NOTES:
This is a planning drawing and is not to be used for construction.
Proposed amendments to approved drawings 23/00189/LBC are shown in red.

Rev H 24.03.2024 Planning issue. GF glazing amends, 1 RL, render and roof notes added.

**LITTLE JERICHO
BLACKMORE**

PROPOSED ELEVATIONS

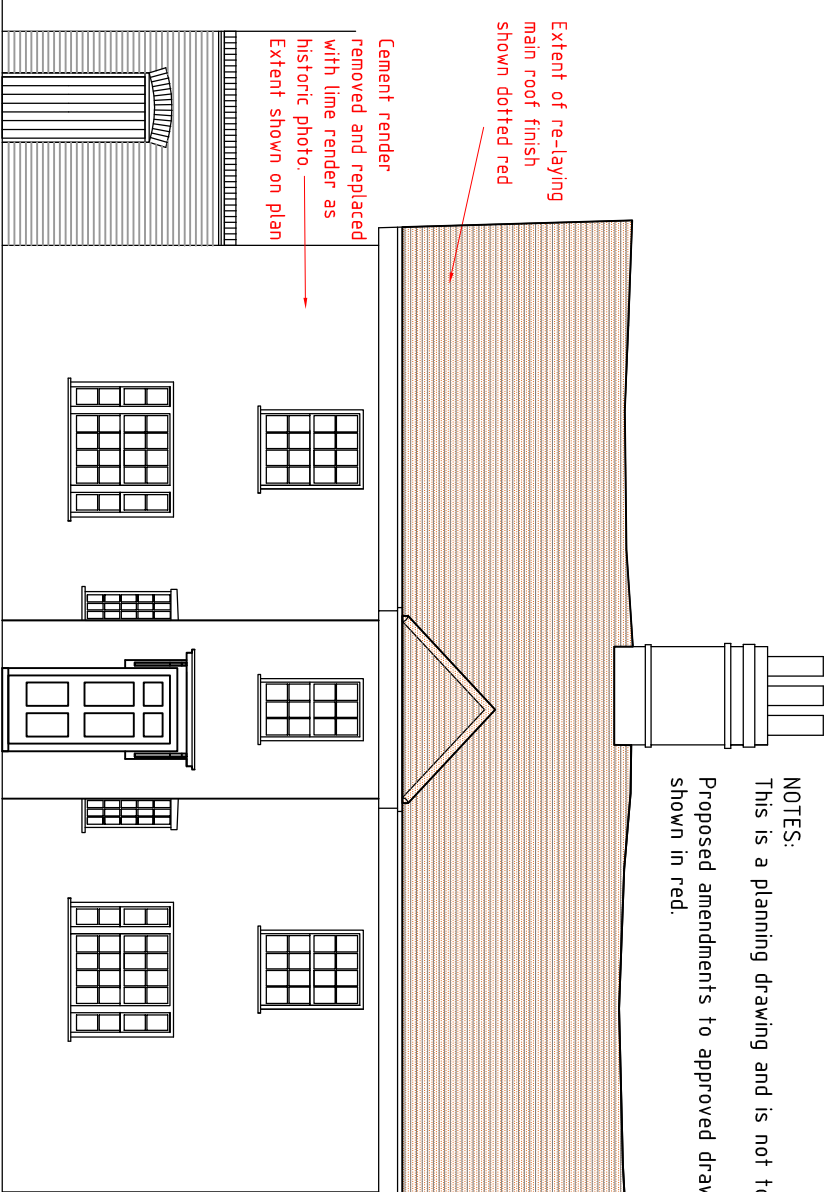
15 Storey replacement Extension
1 storey behind garden wall
Glazed panel reduced, amended to sliding door

Extent of re-laying main roof, porch and stair roof finish shown dotted red
Rooflight Company Neo-06 531Wx842H
Bath window with frosted glass and restrictor
Existing C20 top floor window. Replace with painted timber side opening casements with rebated meeting stile detail for exit in emergency. See drawing 24.2.20
Existing C20 top floor window. Replace with painted timber side opening casements with rebated meeting stile detail for exit in emergency. See drawing 24.2.20
Extent of re-laying main roof, porch and stair roof finish shown dotted red

Extent of re-laying main roof, porch and stair roof finish shown dotted red
Cement render removed and replaced with lime render as historic photo. Extent shown on plan
Amend to sliding door
